SAFETY AUDIT

STAGE 1/2

Wadsworth Gardens PROWs, Cleckheaton

**ON BEHALF OF
BARRATT & DAVID WILSON HOMES**

PROBLEM LOCATION PLAN 1

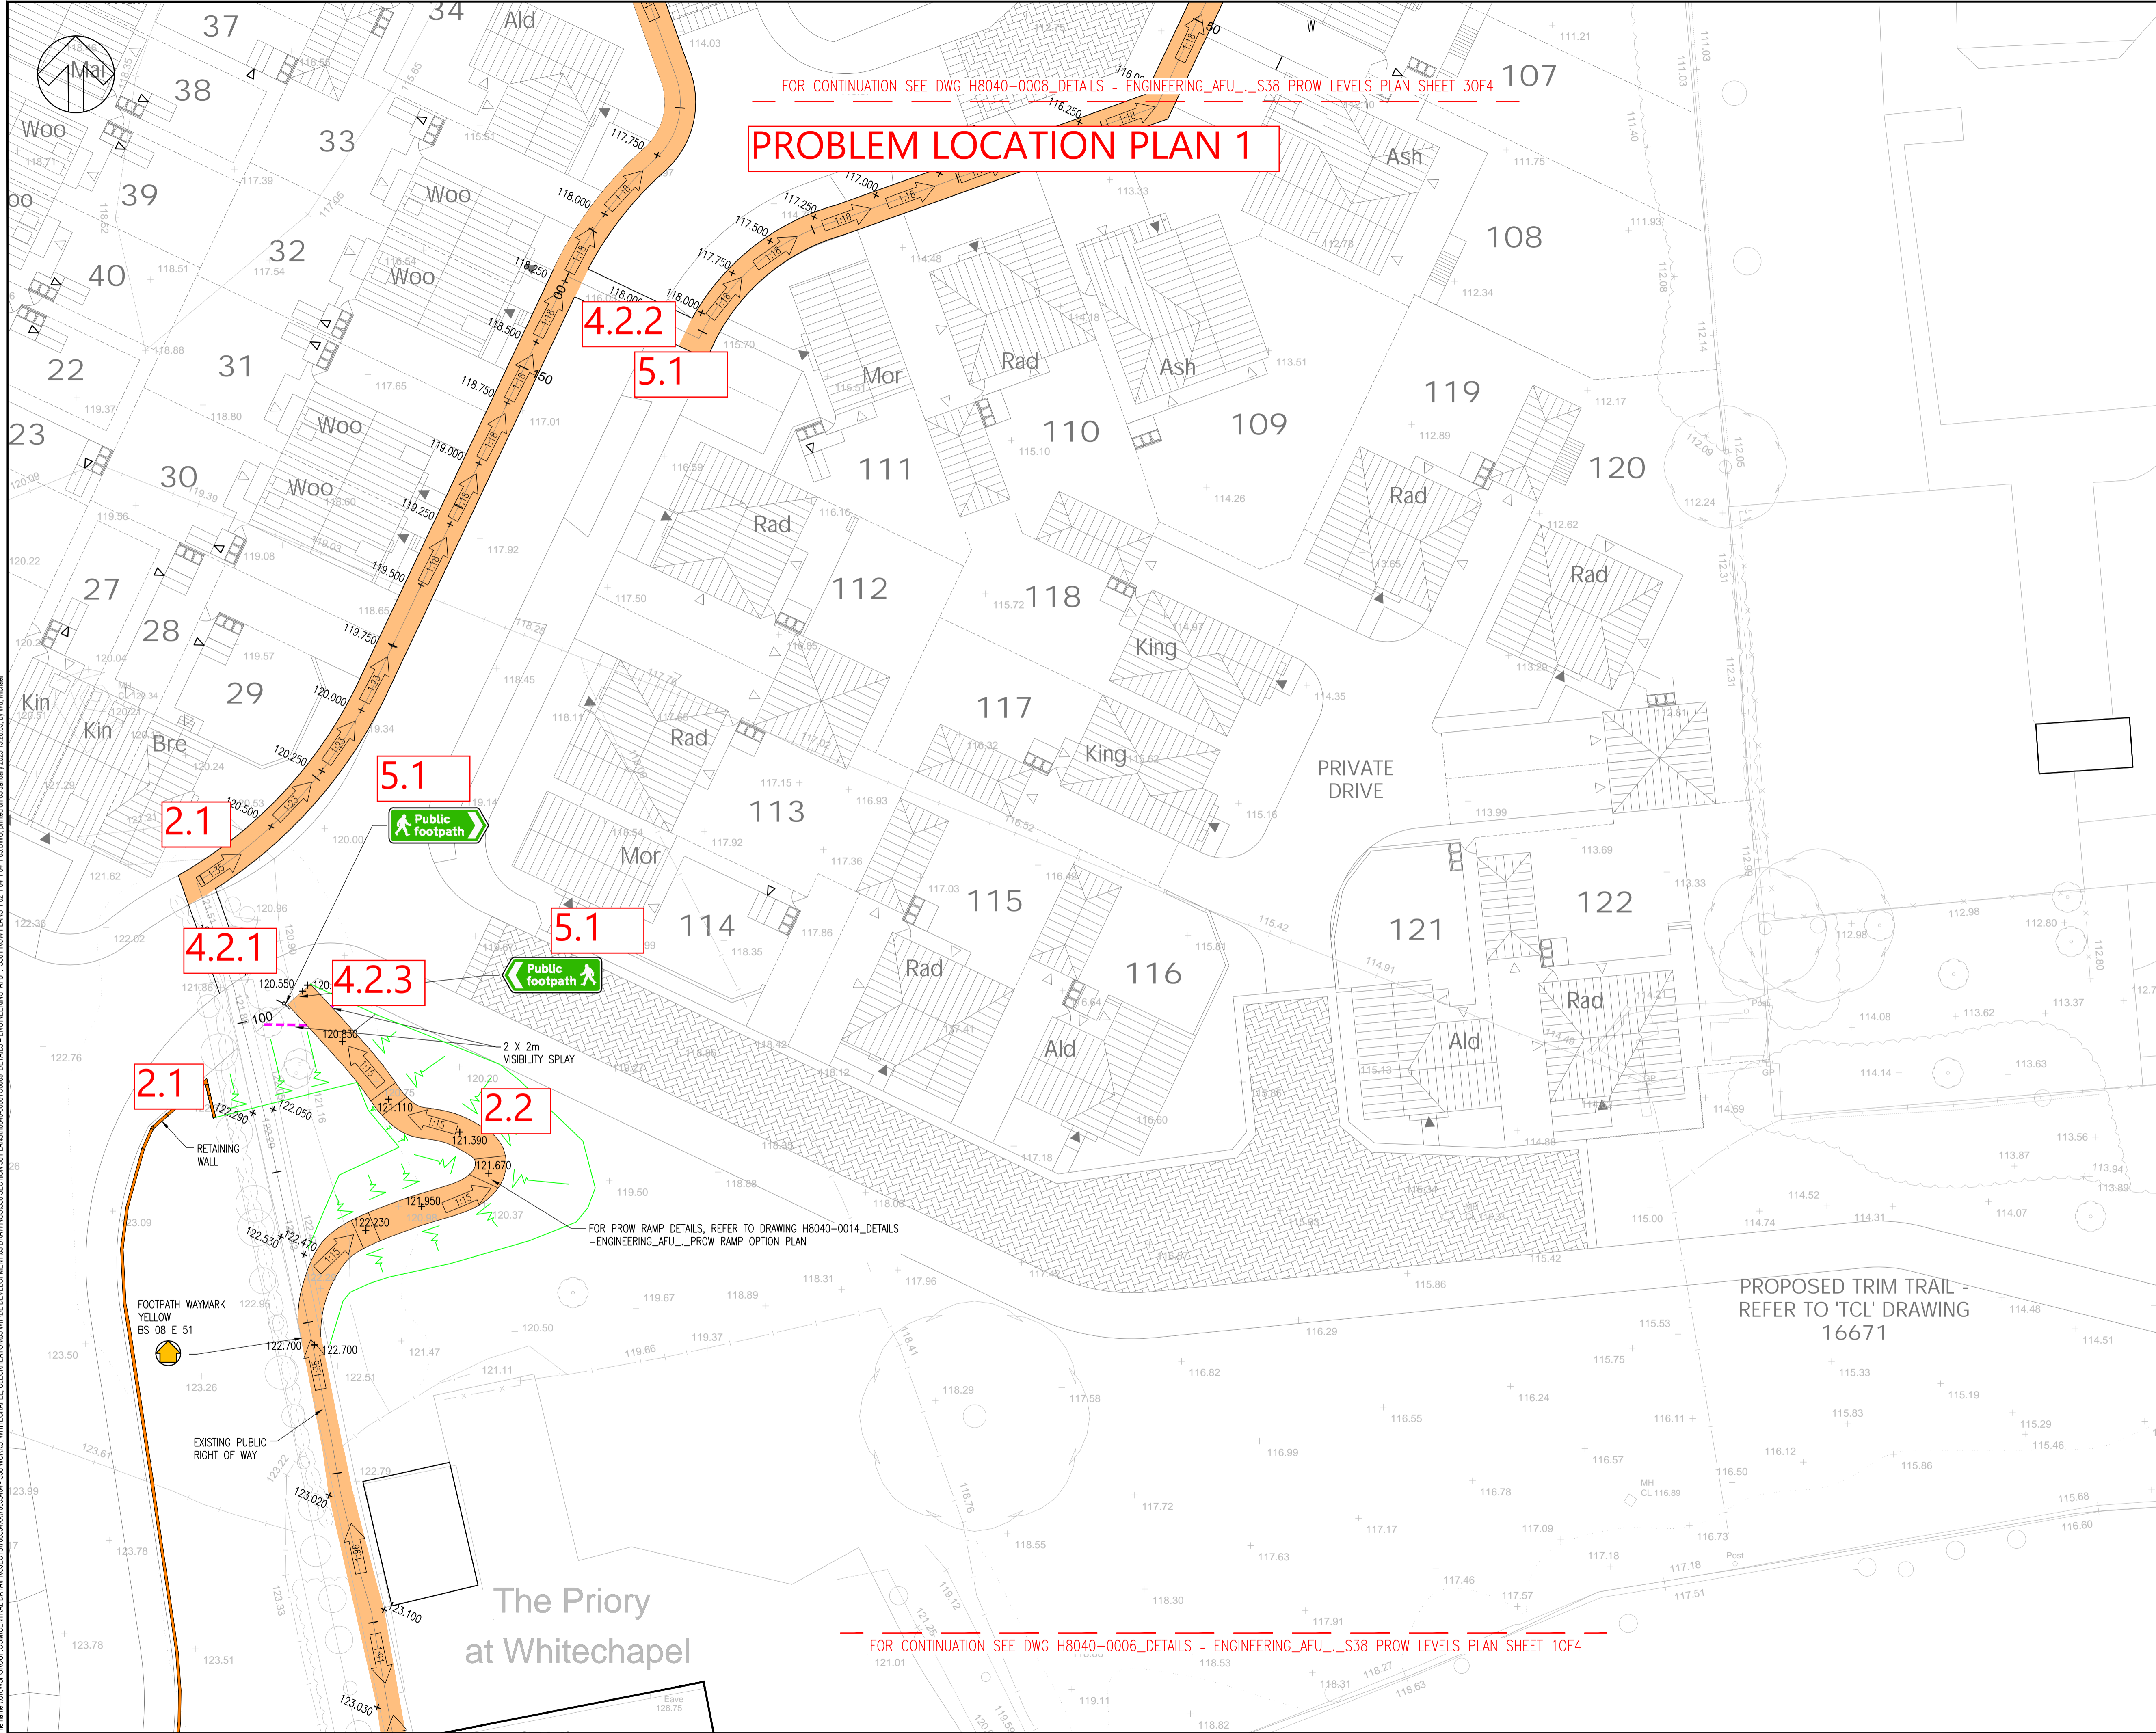
2.1 Problem: Visibility for pedestrians crossing Road 1

Location: Adjacent to bottom of proposed ramp (plots 28 / 29)

Summary: *No visibility splays shown on the drawings for pedestrians crossing Road 1 adjacent to the bottom of the proposed ramp in the new PROW near plots 28 / 29. It is unclear whether adjacent boundary treatments / retaining wall parapet would obstruct splays placing pedestrians in danger.*

No visibility splays are shown on the drawings for pedestrians using the proposed crossing location for the new PROW adjacent to the bottom of the ramp near plots 28 / 29. Pedestrians crossing from south to north after emerging from the ramp would have to look left over the retaining wall to view oncoming traffic. It is not clear whether the height of this wall relative to the vertical alignment of Road 1 would prevent a pedestrian from observing an approaching vehicle and vice versa.

For pedestrians crossing at the same location but from north to south, it is not clear whether there is sufficient visibility afforded to a pedestrian within the proposed highway of vehicles approaching from the north and vice versa without cutting across into private garden areas where planting might obstruct their view.

Failure to provide adequate visibility for pedestrians to judge whether it is safe to cross a carriageway could lead to collisions.

2.2 Problem: Design of Proposed Ramp

Location: Off Road 1 opposite plots 28 / 29

Summary: *The design of the proposed ramp does not fully address usage by vulnerable users with mobility difficulties. There are no measures proposed for aiding people with vision or mobility deficiencies. These issues could result in potential injuries to such users.*

The proposed ramp is located just off Road 1 opposite plots 28 / 29. It will link the higher level of the existing PROW down to the new road level.

The design of the proposed ramp has gradients of 1 in 15 between platforms of 1.2m in length and will be 2m wide. The proposed alignment will place users some 1.8 – 2.0m above the proposed levels of the adjacent highway on a sharp bend in the ramp with no indication to people with vision deficiencies of a safe edge / boundary to follow or provision of hand rails or edge restraints / boundary treatments.

The proposed landings also appear to be quite short particularly for those in wheelchairs or pushing perambulators.

Therefore, the ramp as proposed may cause safety issues for users with mobility or vision deficiencies.

4.2.1 Problem: Location of crossing point of Road 1

Location: Adjacent to bottom of proposed ramp (plots 28 / 29)

Summary: *The location of this crossing point is not clear to approaching drivers.*

The location of this crossing point on a tight bend is not readily apparent to approaching drivers and the latter might be taken by surprise if say a group of walkers suddenly emerged from the ramp and needed to cross the road.

The above deficiencies could result in collisions with pedestrians crossing at less safe locations.

4.2.3 Problem: Proposed ramp might encourage children to over run into the carriageway

Location: Adjacent to bottom of proposed ramp (opposite plots 28 / 29)

Summary: *The proposals indicate that the ramp will approach Road 1 with a 1 in 15 gradient with no measures to prevent children from using it and over run in to the carriageway and conflict with traffic.*

The drawings indicate that the proposed ramp will have a 1 in 15 straight gradient down towards the footway to the south side of Road 1. A dropped crossing is also proposed in this location. The Audit team consider the ramp will be very attractive to children playing on it with skateboards / scooters / cycles etc.

There is potential for the above usage to result in children over shooting the footway and landing in the live carriageway of Road 1 and be in conflict with moving vehicles.

It is recommended that the drawings be amended to show that adequate visibility can be achieved at this crossing point for pedestrians and boundaries / treatments be designed so as to avoid them being obstructed.

It is recommended that the ramp design be reviewed against current good practice guidance and drawings be amended to provide people with vision deficiencies guidance in its use and route and protection from the level difference and adequate landing lengths for wheelchair users and those with perambulators.

It is recommended that the presence of the crossing point is highlighted by either the provision of a different colour / texture of road surface and / or placed on a flat top speed hump.

It is recommended that a staggered barrier be provided at the bottom of the last gradient of the ramp which may require localised widening of the latter to facilitate this.

PROBLEM LOCATION PLAN 2

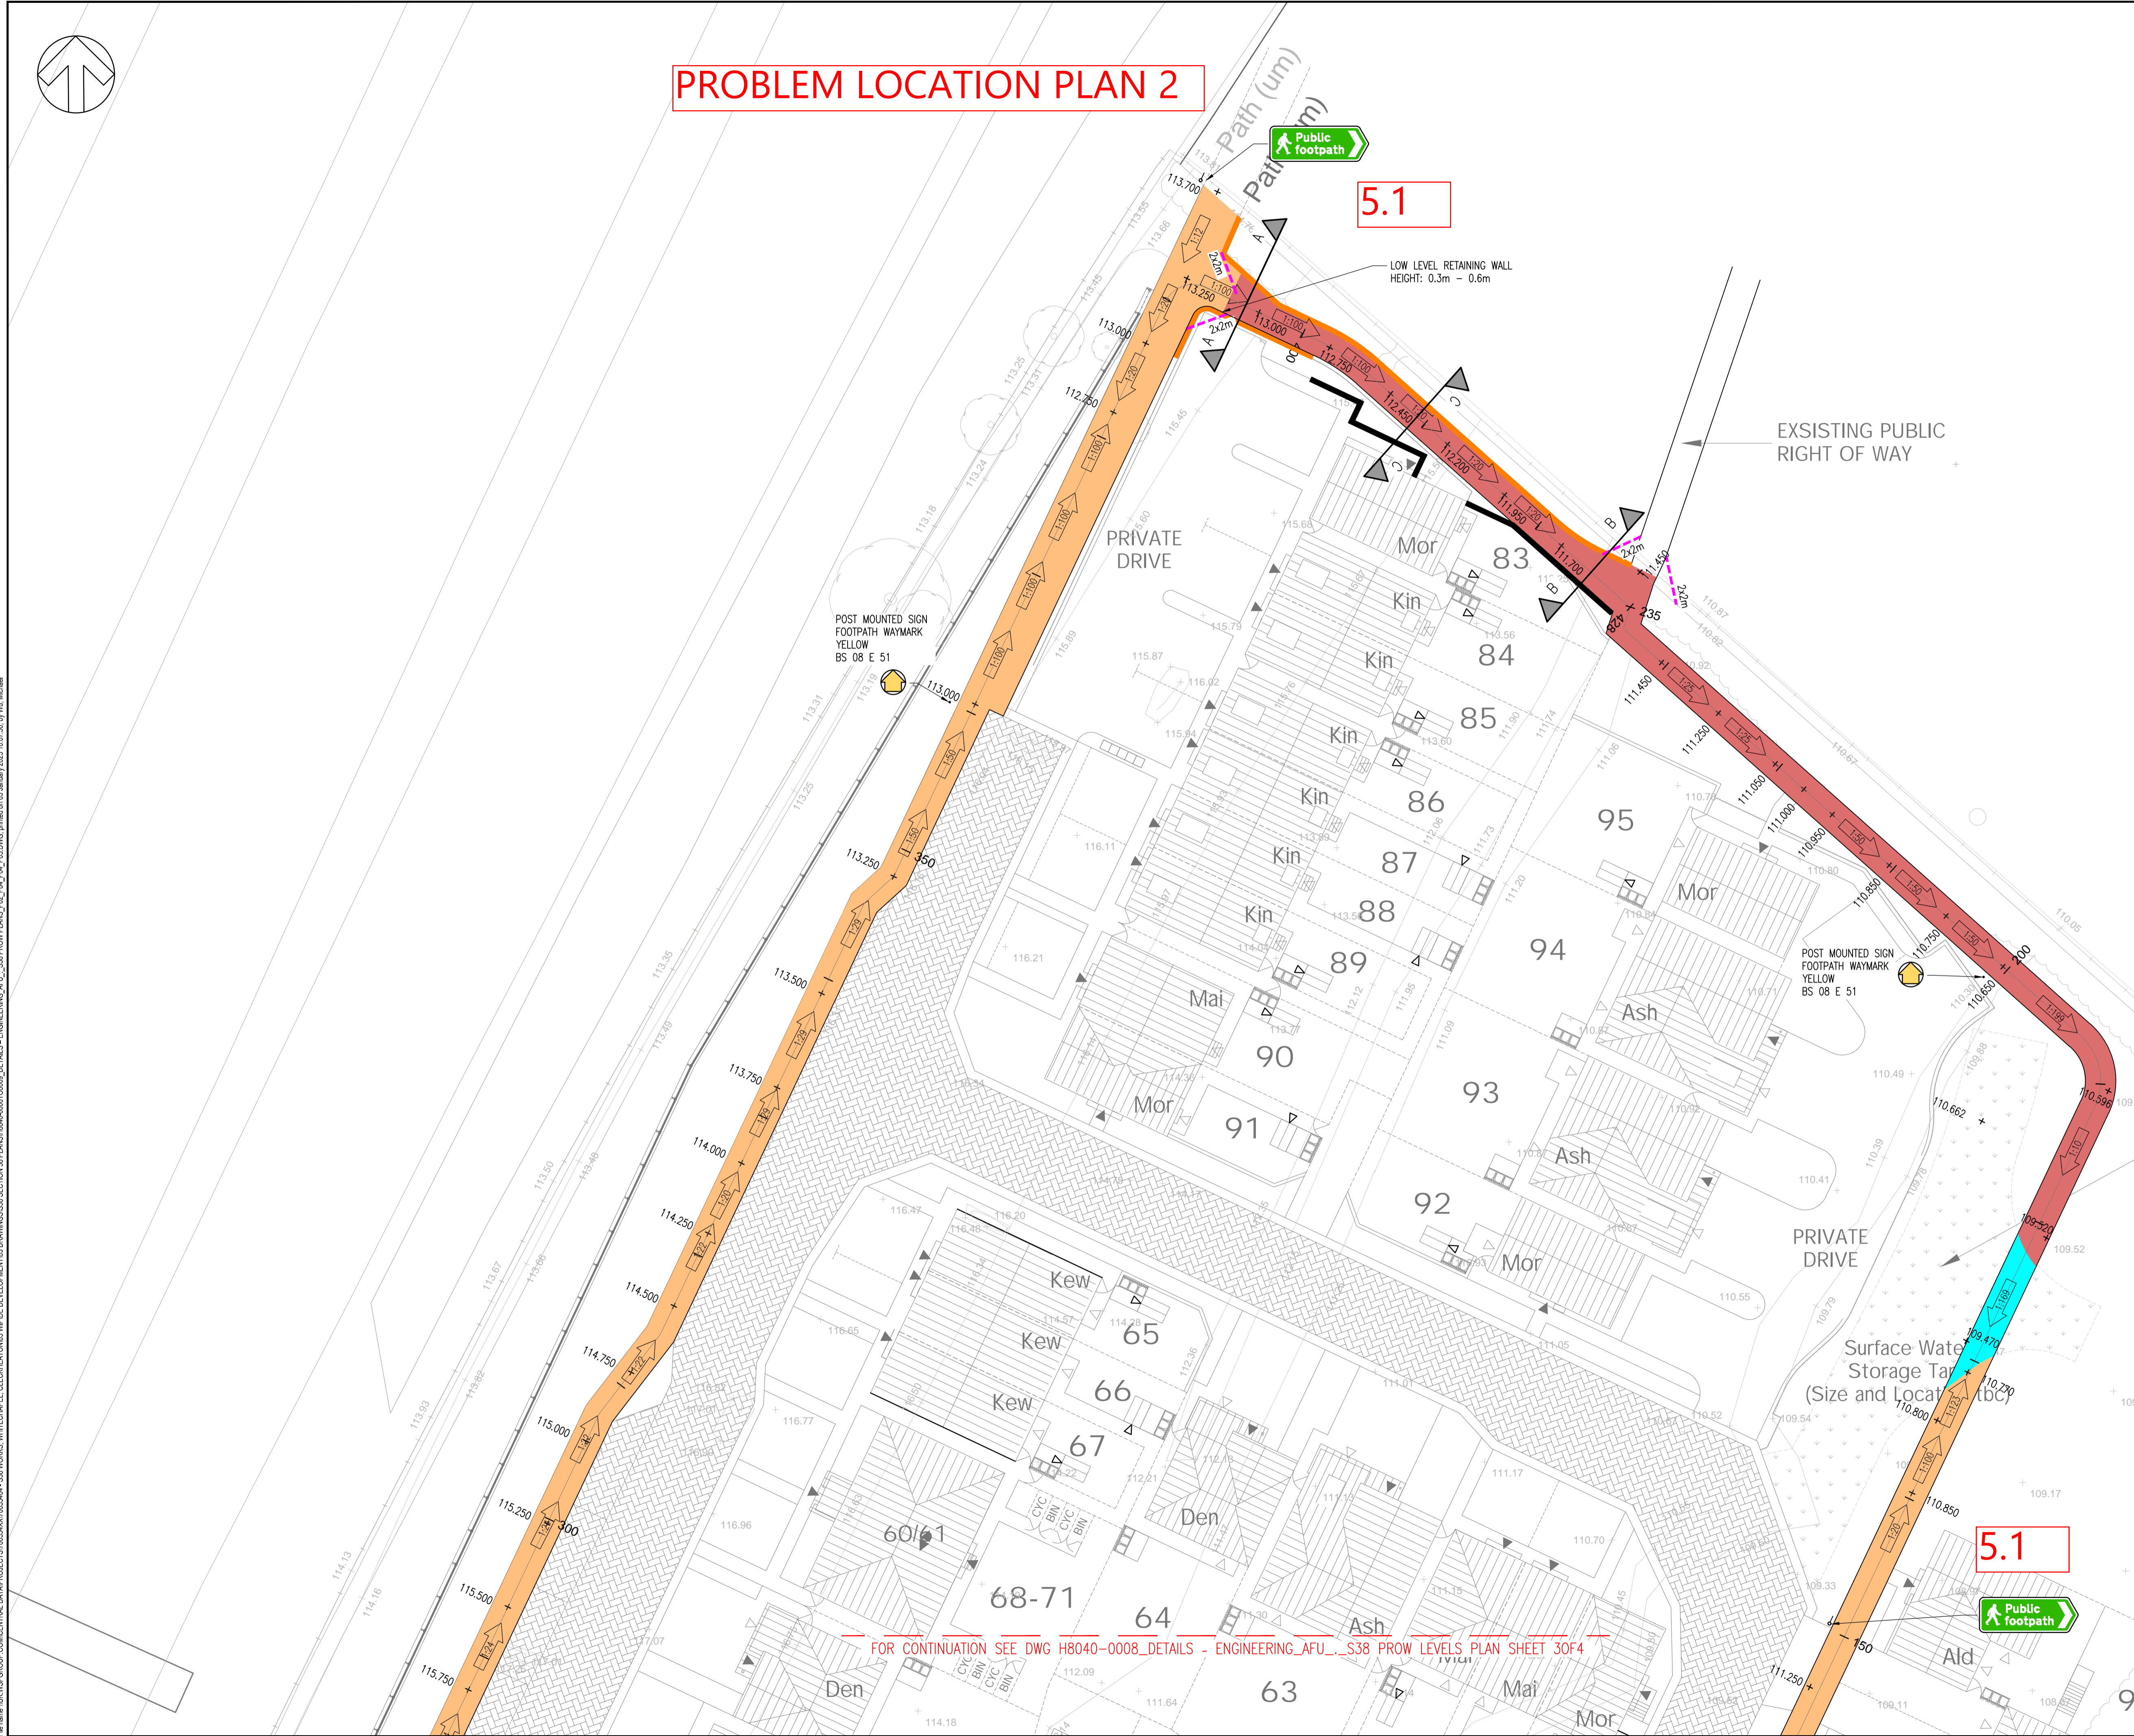
4.2.2 Problem: Location of crossing point of Road 1

Location: Road 1 adjacent to plot 111

Summary: *The proposals indicate that part of the diverted PROW will cross Road 1 in the vicinity of plot 111. This uses the vehicle crossover to the drive to plot 111 and there is no dropped kerb or tactile paving on the opposite footway. Failure to indicate a safe crossing point for pedestrians could lead them to use less safe locations.*

The drawings indicate that part of the diverted PROW will cross Road 1 in the vicinity of plot 111 using the vehicle crossover to its driveway. The Audit Team has noted that there is no dropped kerb or tactile paving on the opposite footway in this location.

Whilst the potential for a crossing pedestrian being in conflict with a vehicle using the driveway to plot 111 is small, the location is not ideal and would make it difficult to provide tactile paving in that location. The lack of a dropped crossing and tactile paving on the opposite footway would result in people in wheelchairs or with perambulators having to bump over full height kerbing.

Failure to indicate a safe crossing point for pedestrians could lead them to use less safe locations.

It is recommended that the design team review the location of this crossing point and place it away from driveways so as to allow the provision of dropped crossings and tactile paving.
